Title & Document Type: 8405A Vector Voltmeter Operating and Service Manual

Manual Part Number: 08405-90024

Revision Date: May 1971

VECTOR VOLTMETER 8405A

Figure 7-13(b), Schematic Diagram, Voltmeter (CHANGE 17)

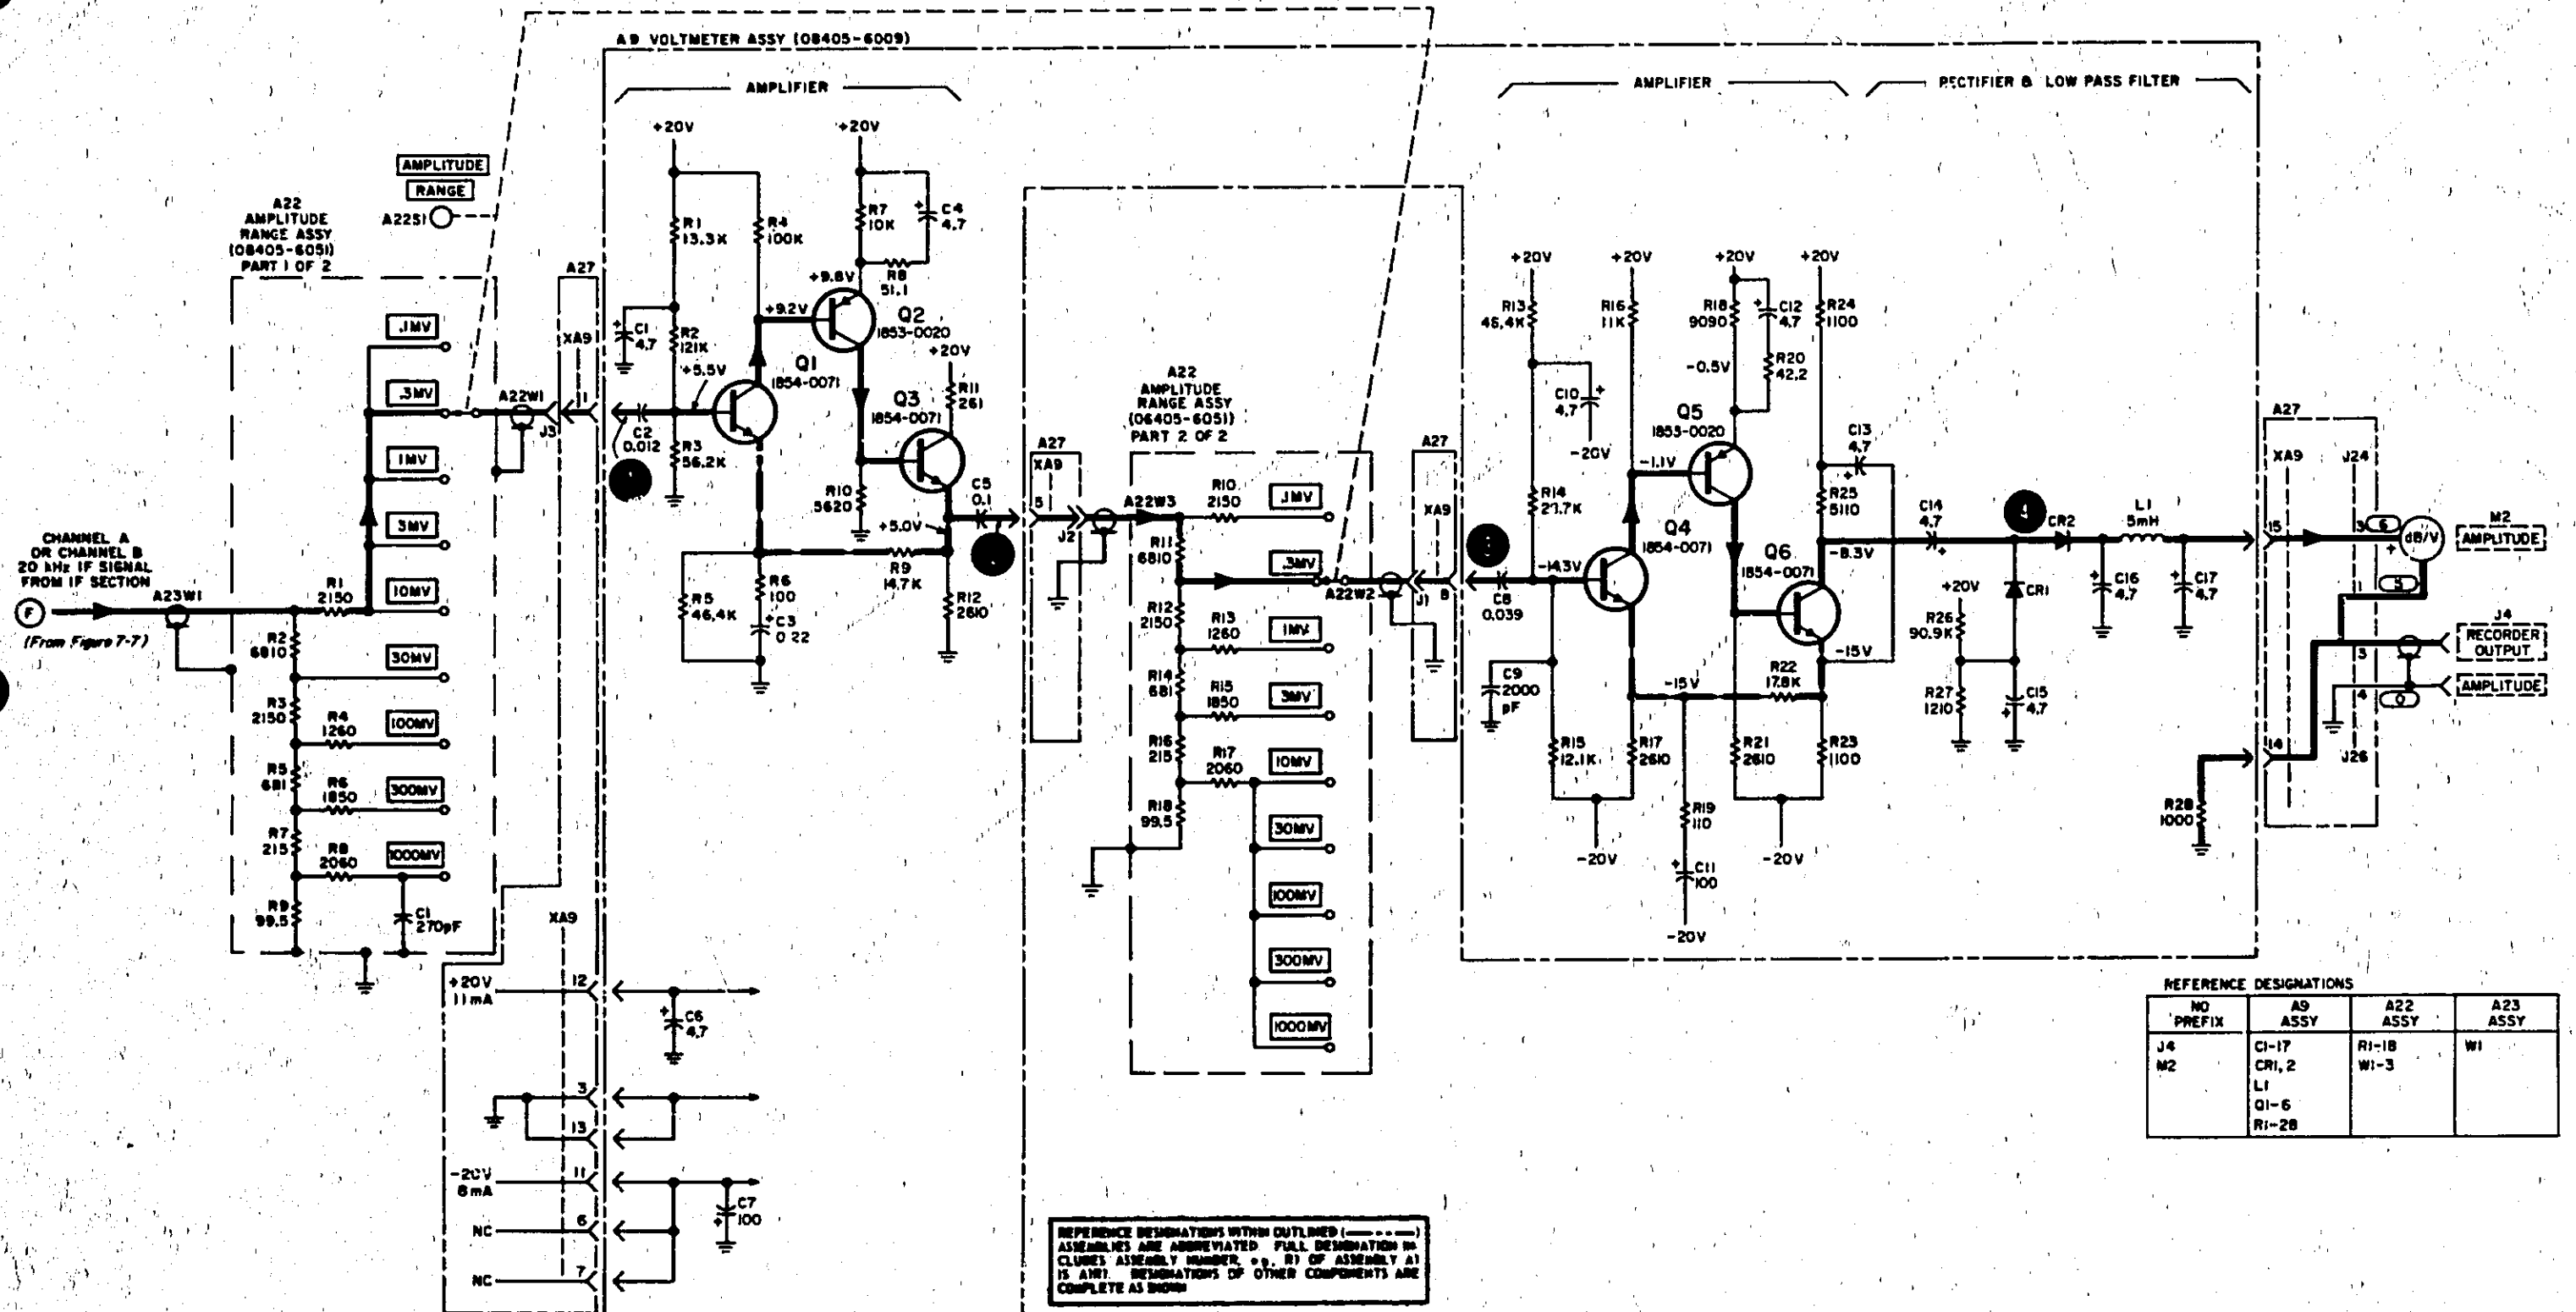
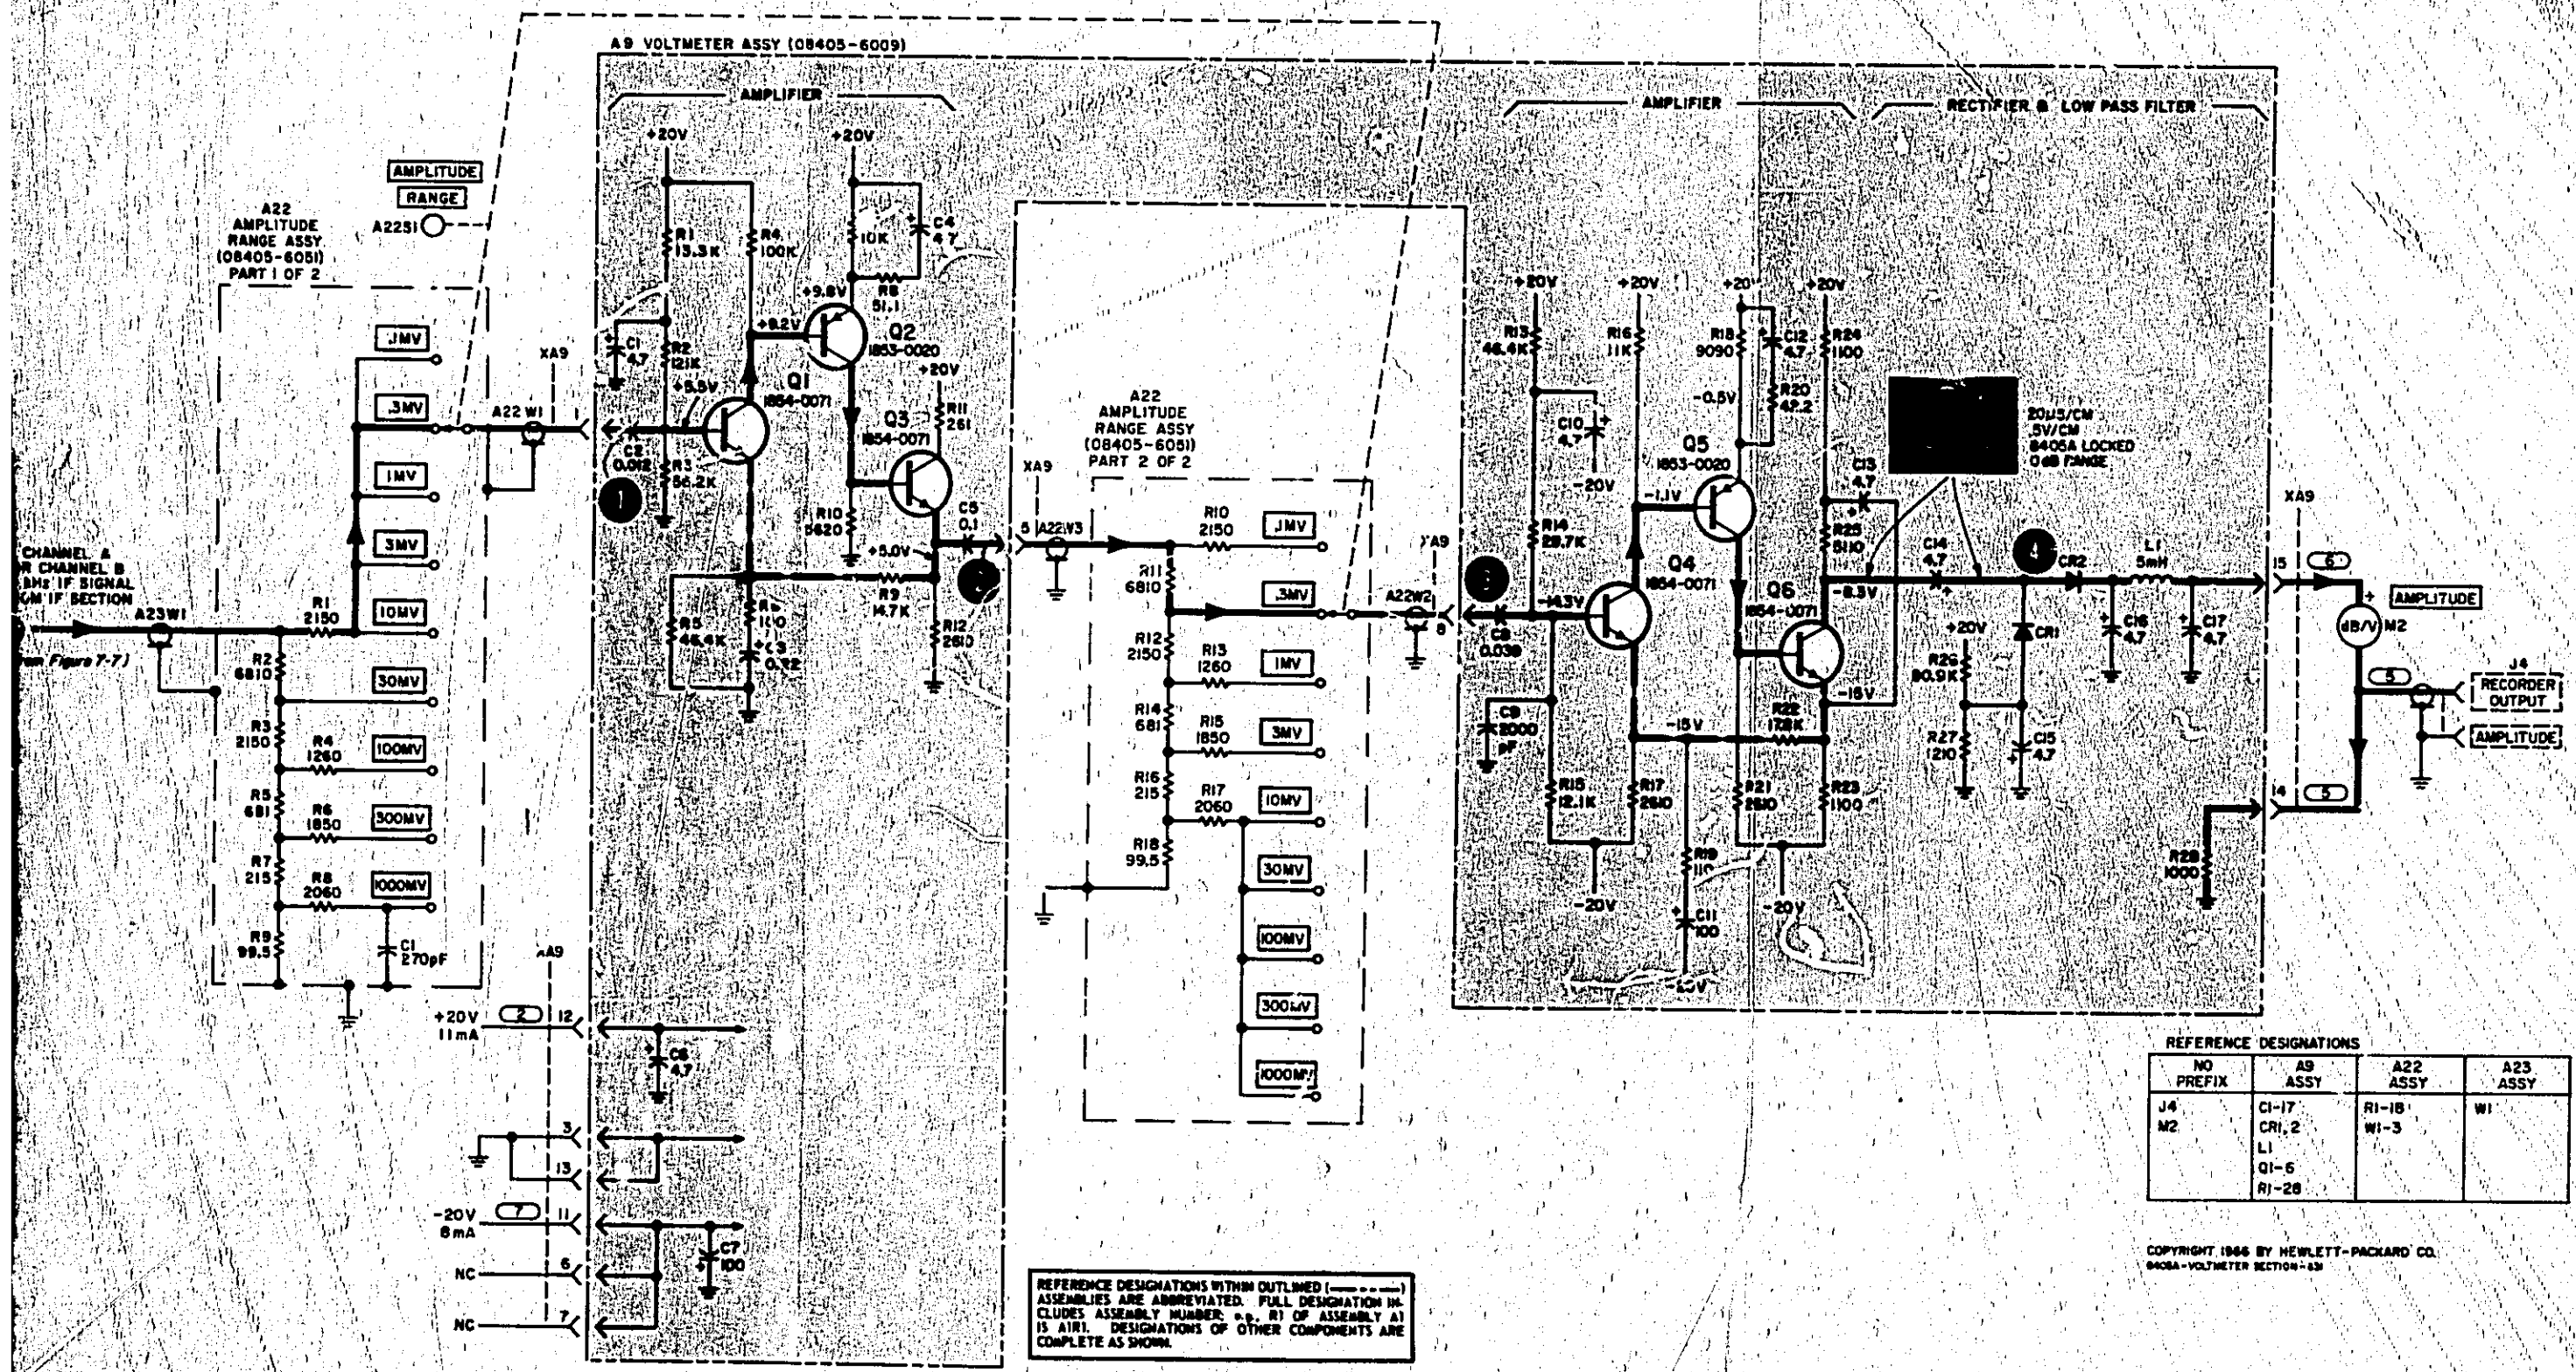
Figure 7-13(b):

Change Figure 7-13(b) of Change 17. The A22 Amplitude Range Assy is identified twice as part number 08405-6051. Replace the part number with this note: See Table 6-1 for current assembly number.
